INTERCOM SYSTEM

87 Beacon Street

To: Nicholas A. Armata, AICP / Senior Preservation Planner
Beacon Hill Architectural Commission

Re: Violation Notice / VIO.23.0641

**EXISTING INTERCOM
87 BEACON STREET**

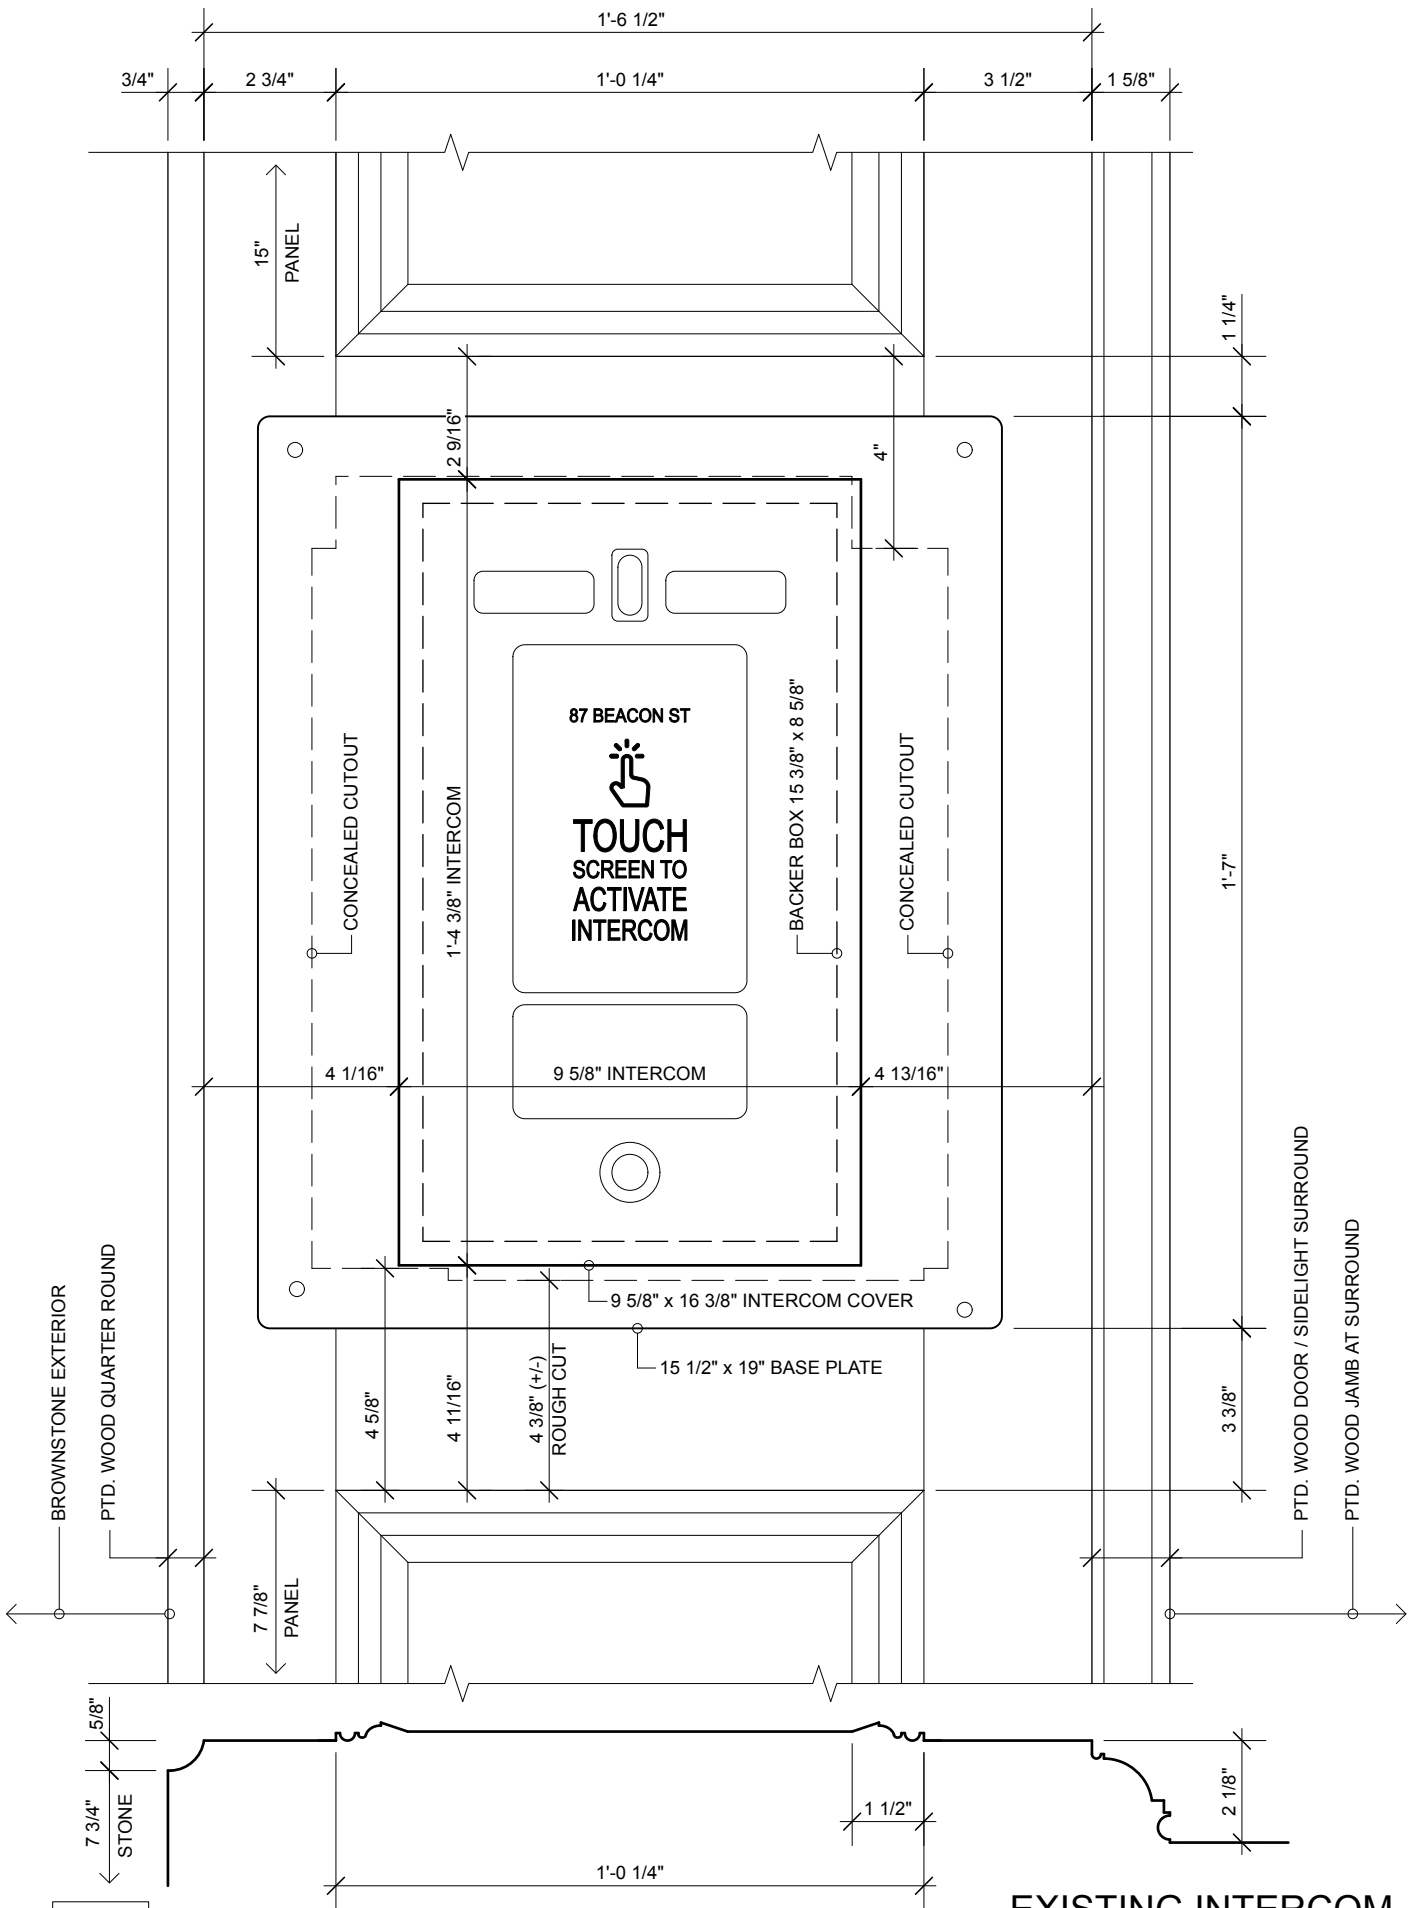
While the intercom panel is flush mounted in the wood trim and contained within the entryway, it does not conform to the allowed materials, absence of illumination, or individualized buzzers. The intercom has an interactive visual display panel in a stainless steel flush enclosure and is attached to an oversized brushed stainless steel base plate to conceal the wood cutout for the former intercom. We propose to correct this violation by providing a hinged brass cover per the attached drawings:

Scaled Drawing of Existing Intercom in Entrance Surround

**EXISTING CUTOUT
87 BEACON STREET**

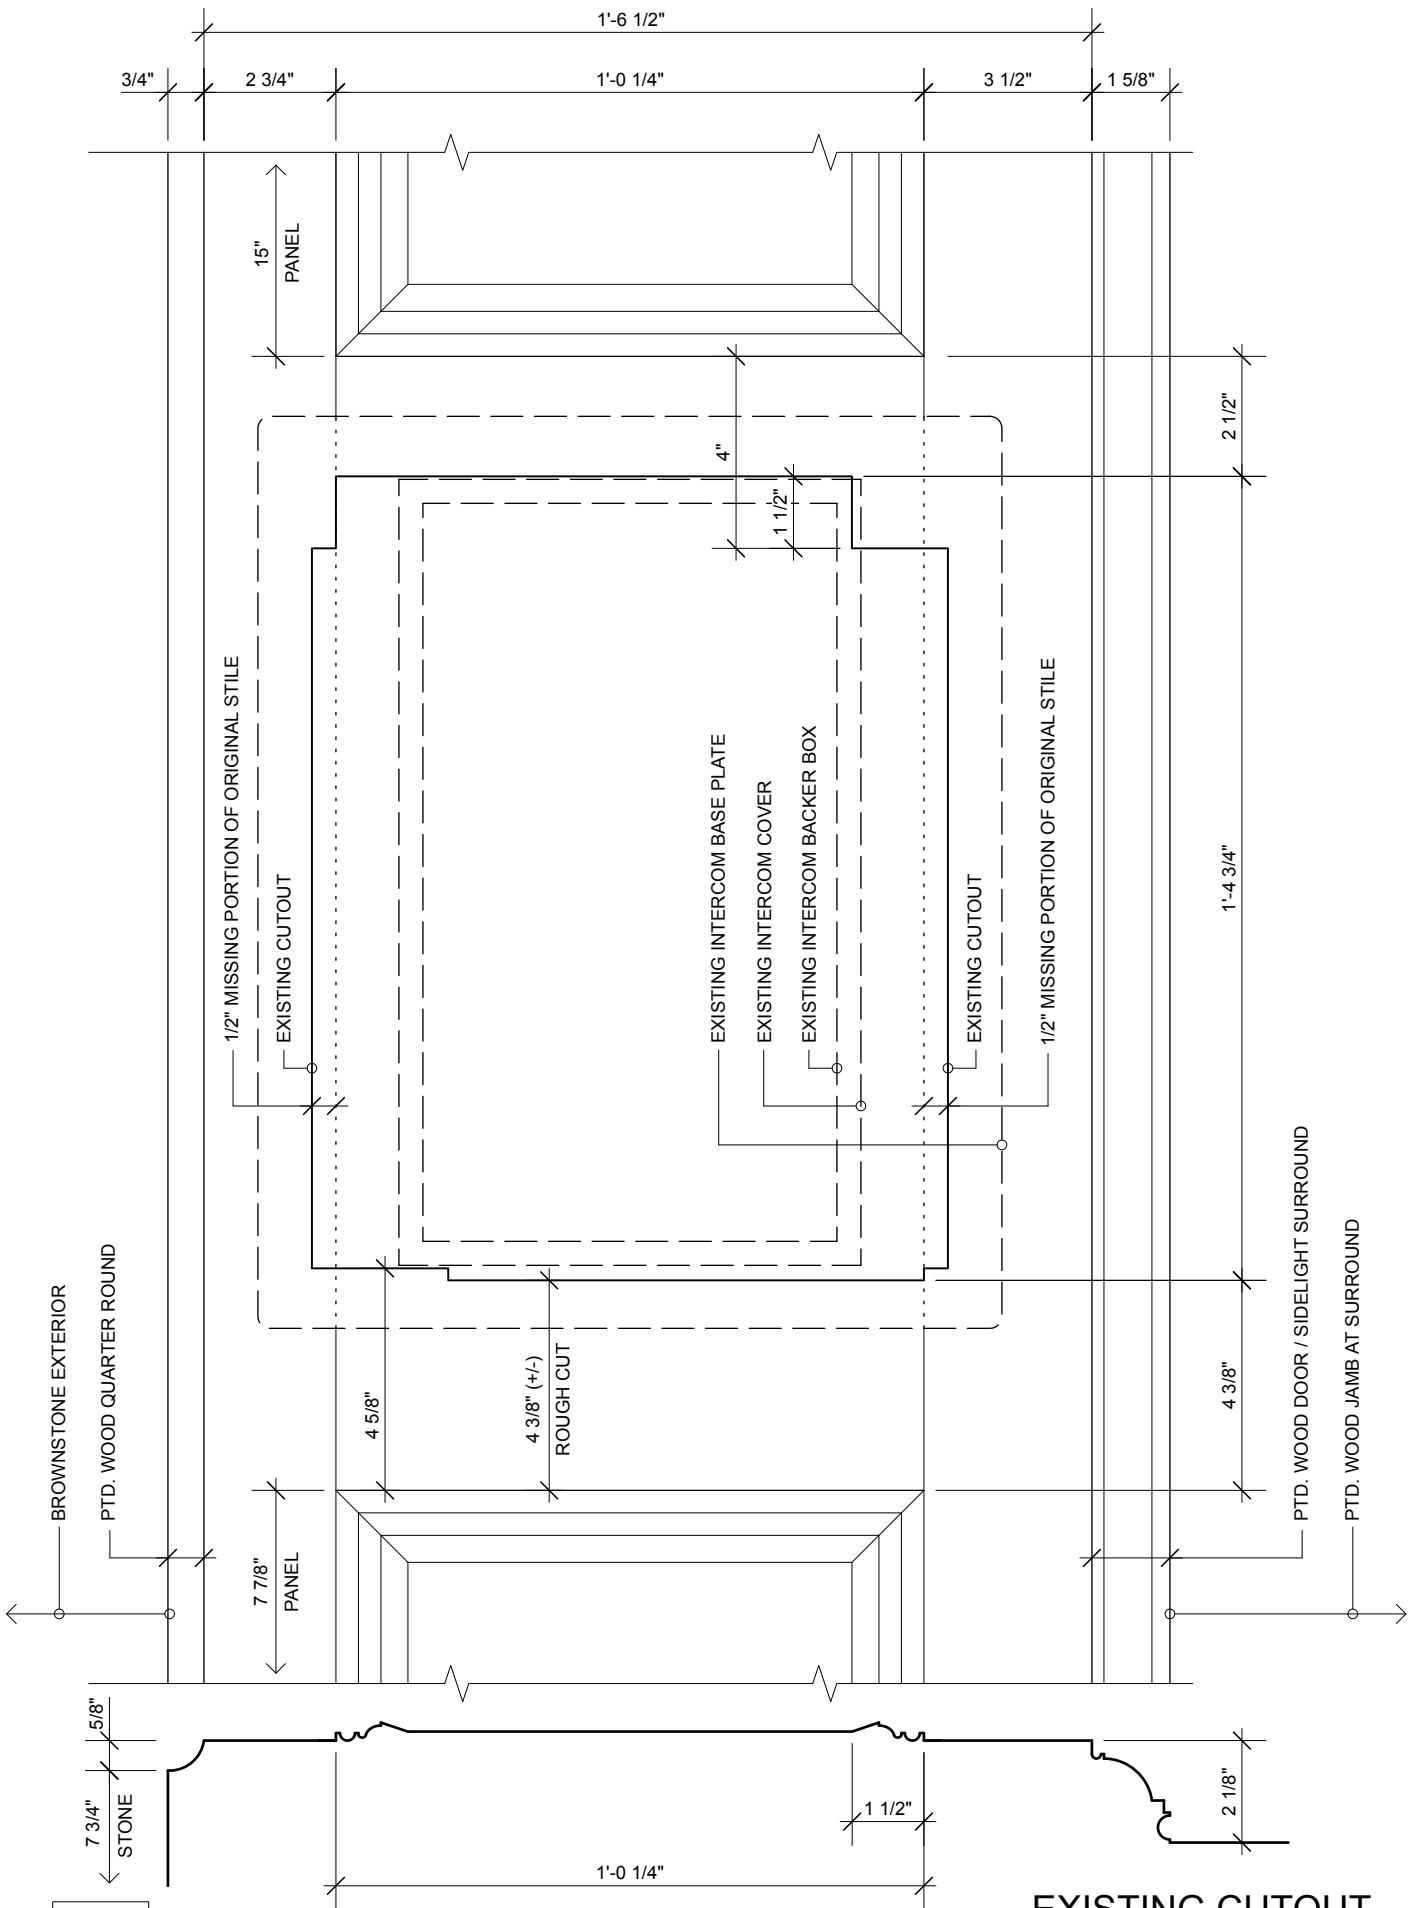
Scaled Drawing of Existing Concealed Cutout in Wood Panel

**REVISED CUTOUT
87 BEACON STREET**

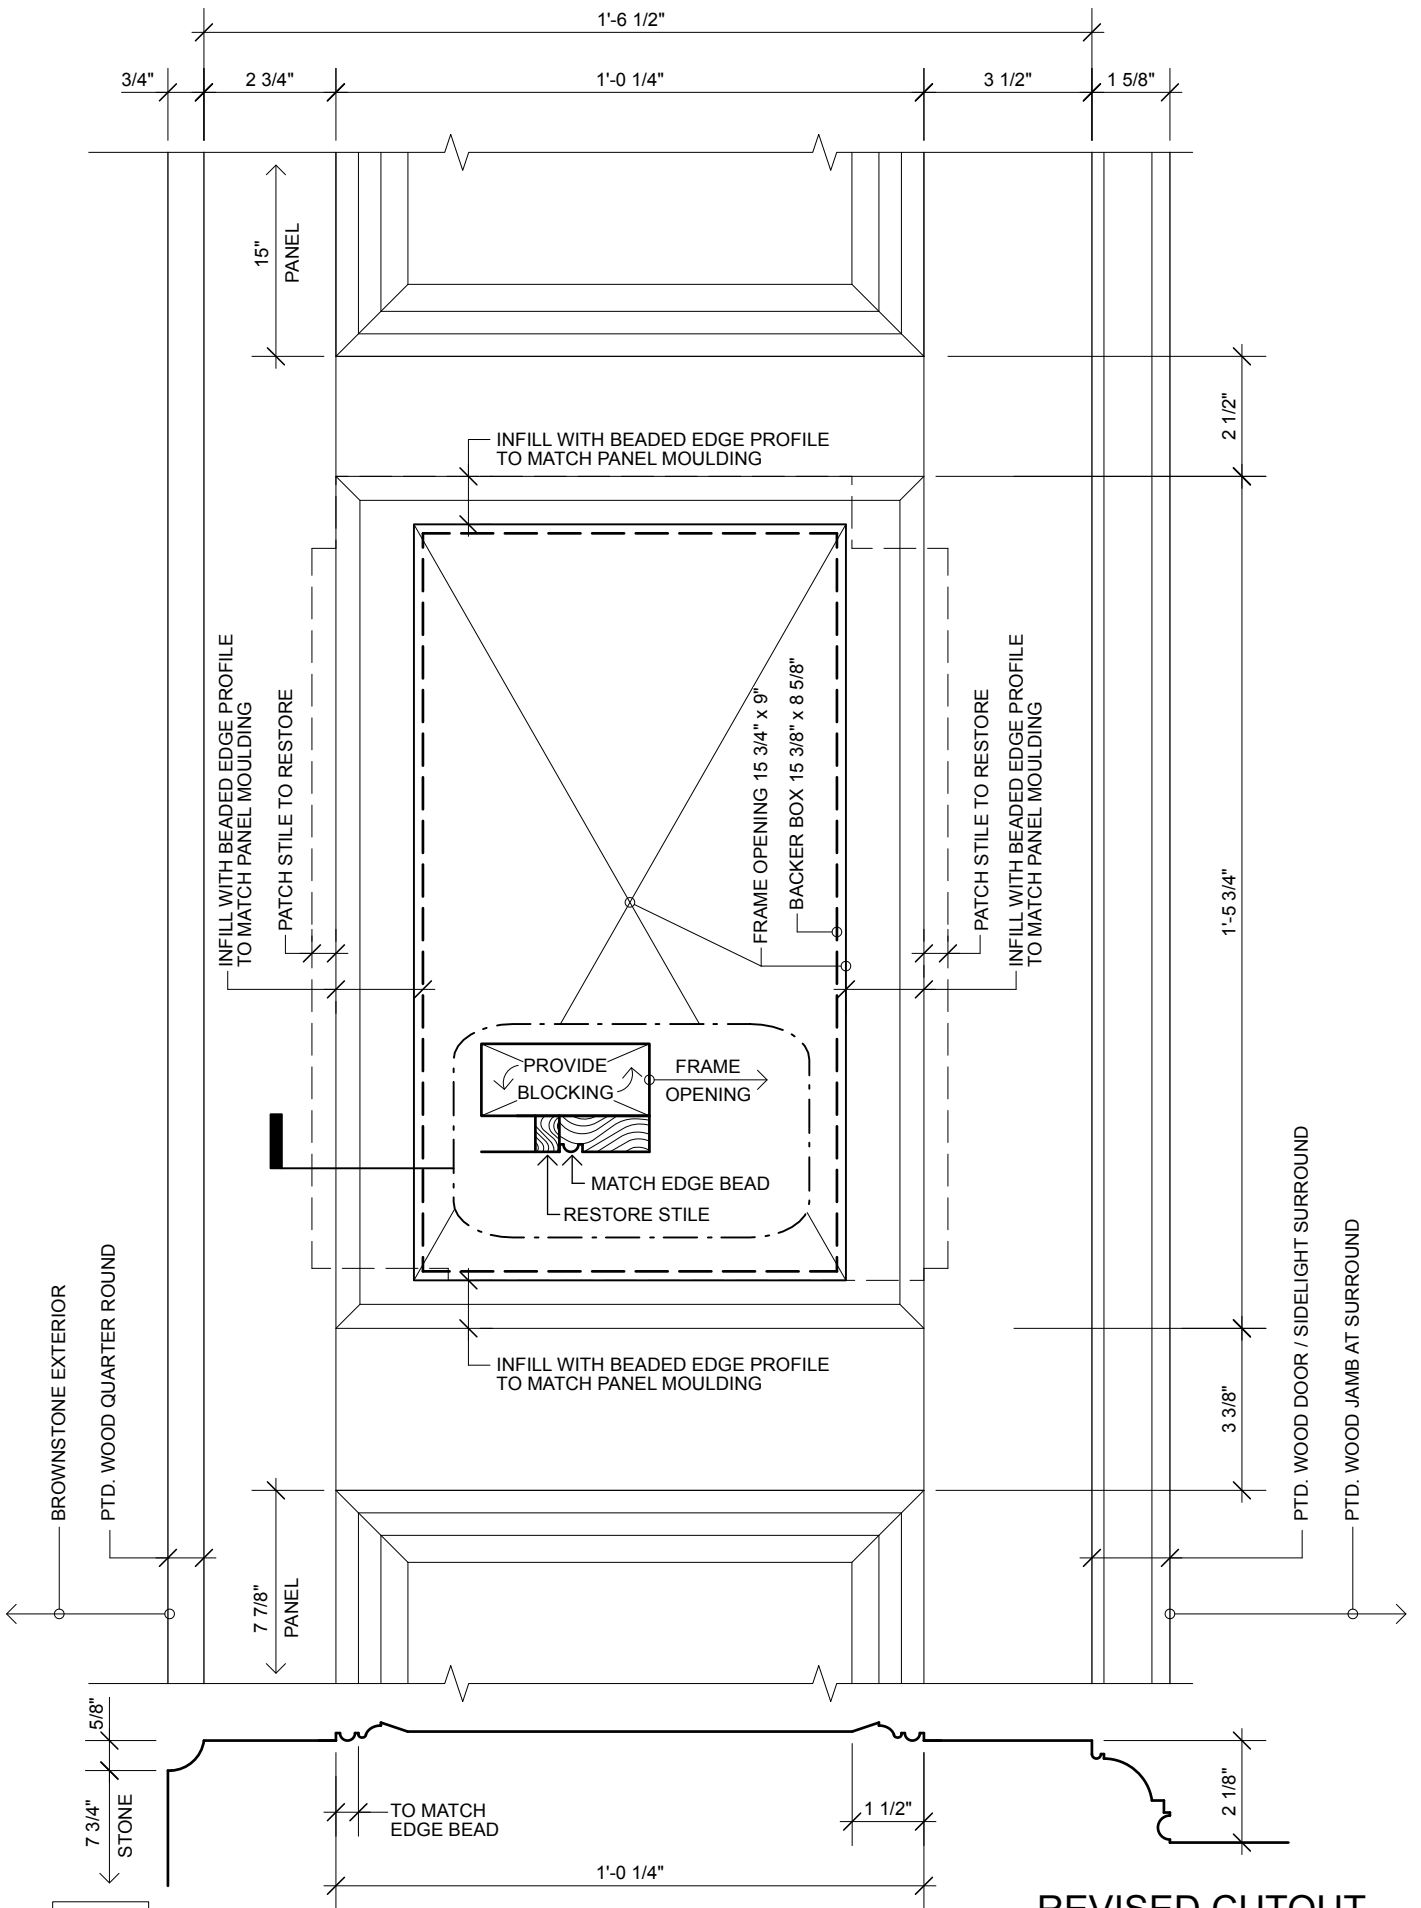
Proposed Revision: Repair Panel Stiles & Provide Beaded Perimeter Panel Edge

**RELOCATED INTERCOM
87 BEACON STREET**

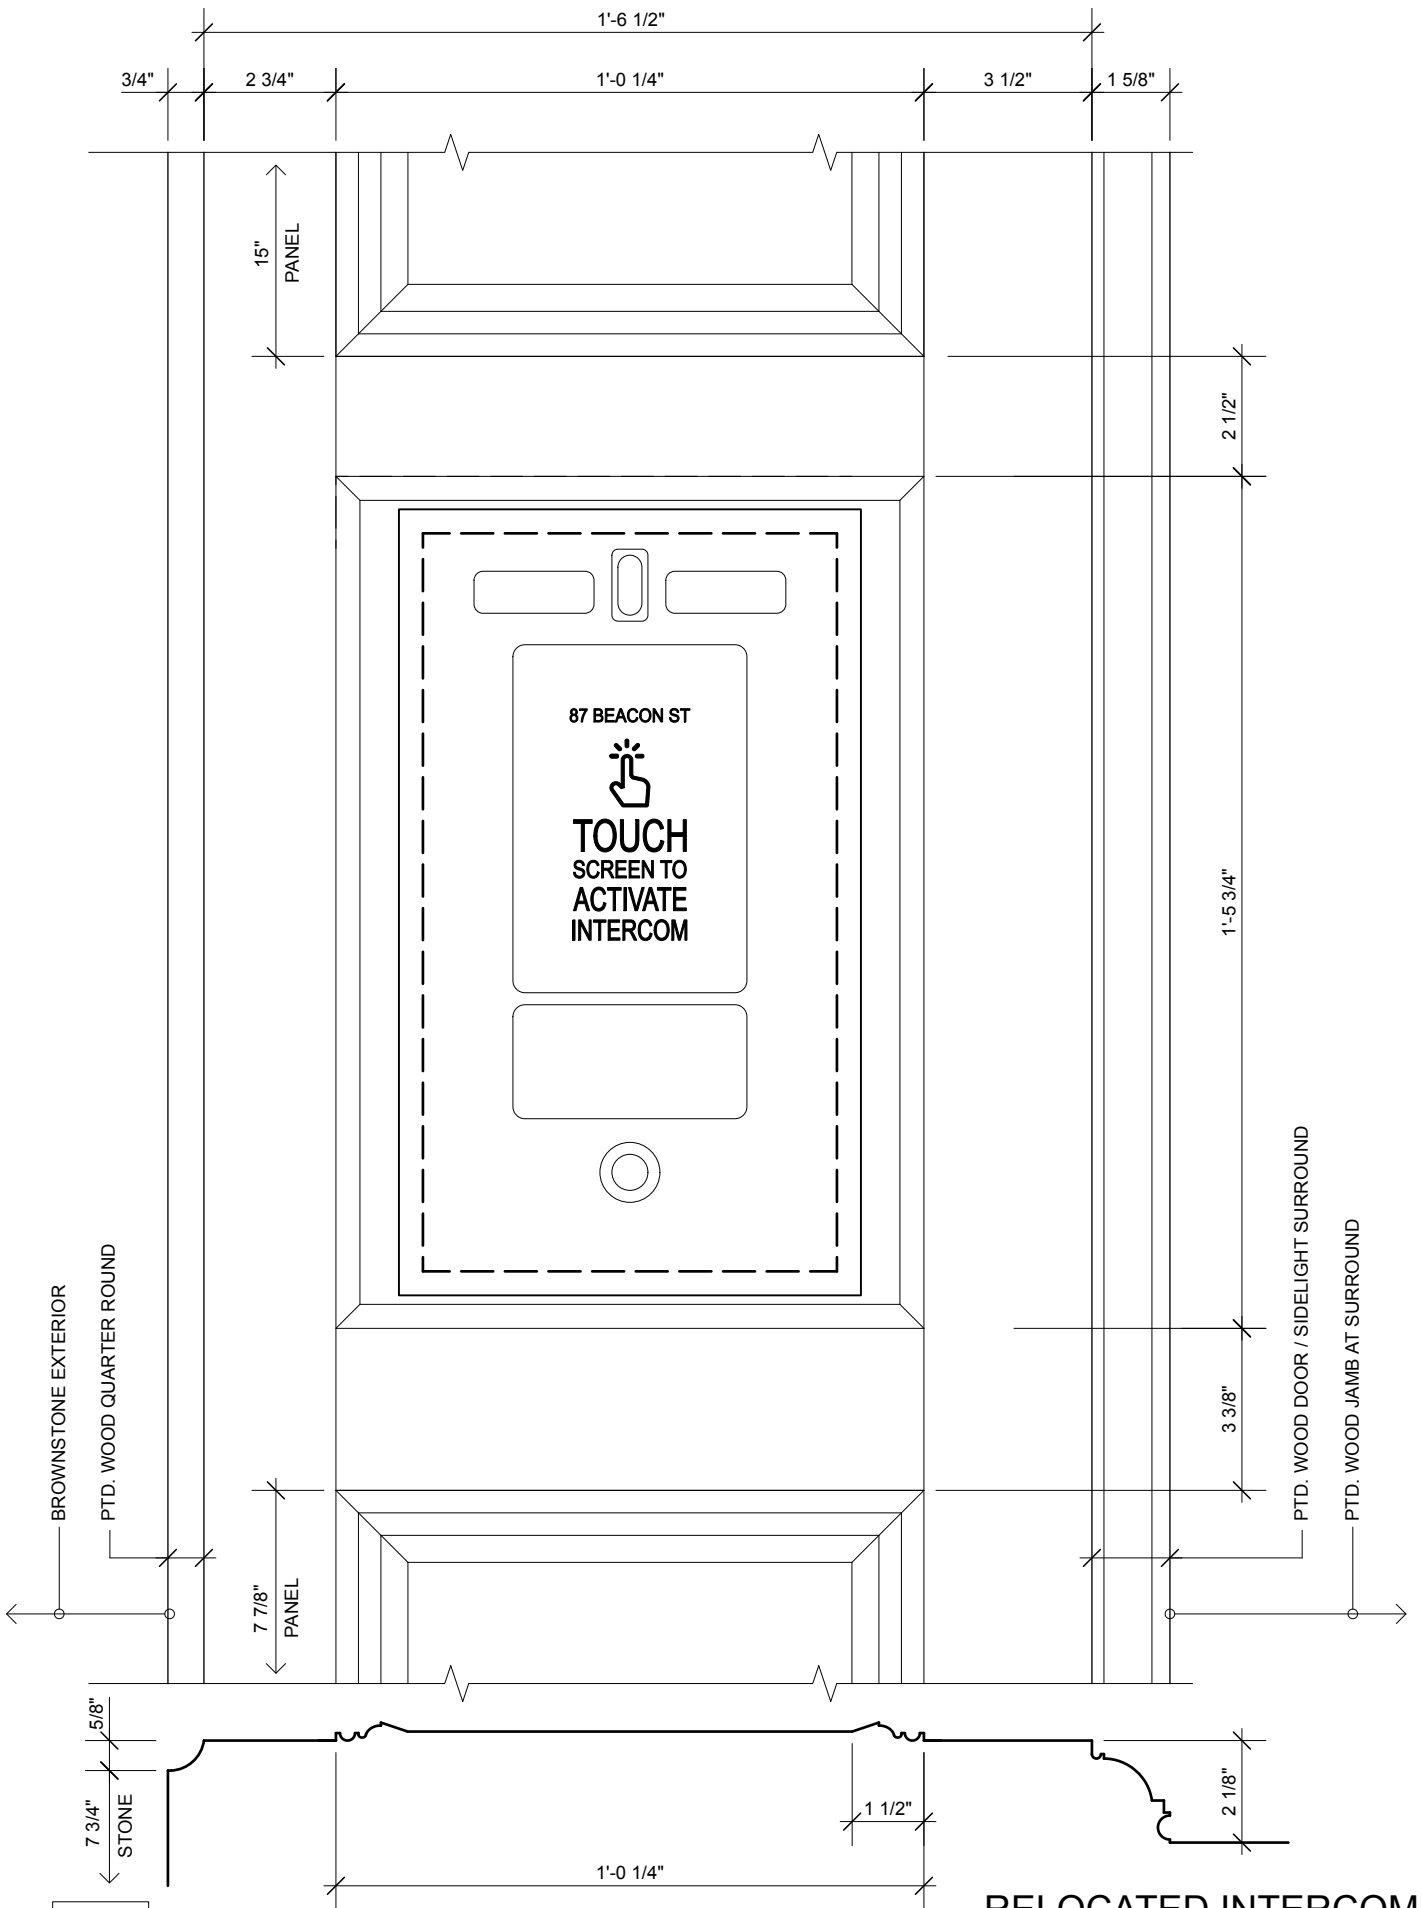
Center the Intercom Panel in Restored Panel Trimmed with Beaded Edge
